## ADDENDUM #1

### ITB 4317 - Clinton Park Tennis and Basketball Court Renovations City of Ann Arbor

APPENDUM # 1

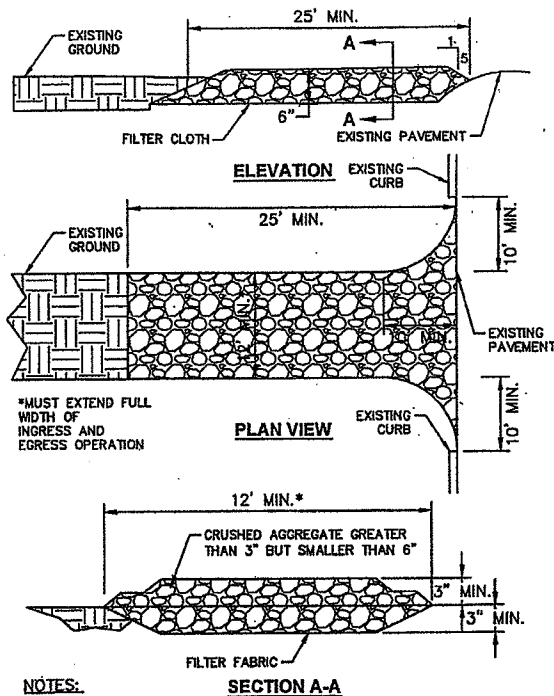
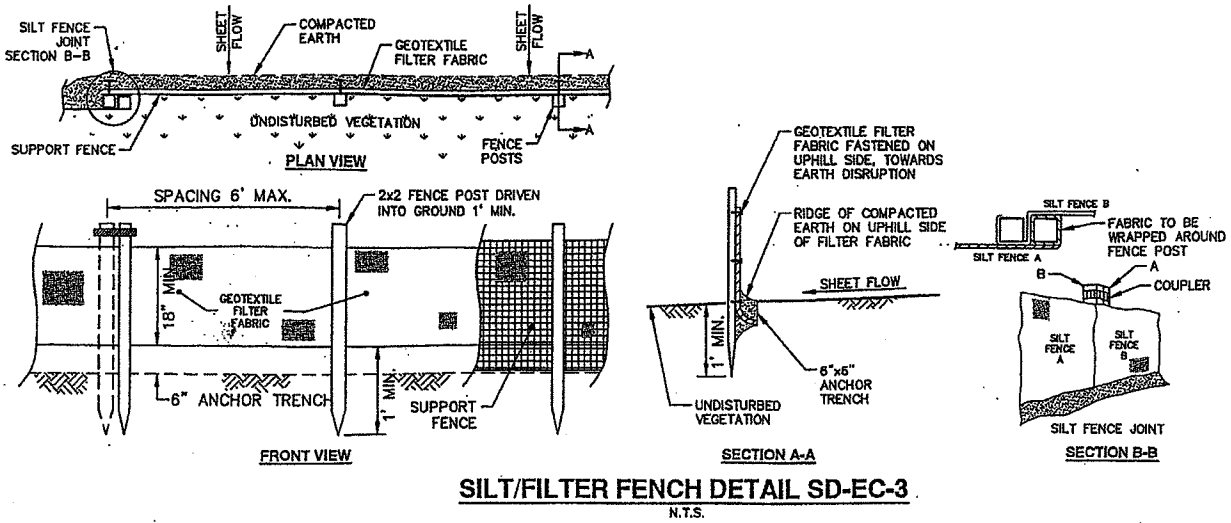
4. Mud tracking – a mud tracking mat shall be added to the entrance where all equipment enters and exits the site. See attached detail.
5. Silt fence is required for this project. See attached detail and quantity on bid form.
6. Testing firm will be hired independently by the City of Ann Arbor.
7. Bids are to be delivered to the first floor Customer Service area of City Hall. The bids will be time stamped by Customer Service staff.
8. Soil boring reports are available upon request.
9. Please use attached replacement bid form and submit with bid. Changes include addition of silt fence, change to quantity of tennis posts, and addition of mud tracking mat within general conditions.

1. MUD TRACKING SURFACE MUST BE LONG AND WIDE ENOUGH TO PREVENT VEHICLES ENTERING AND EXITING THE SITE FROM TRACKING SOILS ONTO THE STREET. ANY SOILS TRACKED ONTO THE STREET MUST BE REMOVED IMMEDIATELY FOLLOWING EACH TRACKING OCCURRENCE.
2. EXISTING CURB SHALL BE REMOVED AND REPLACE AT THE LOCATION OF THE MUD TRACKING SURFACE AREA.
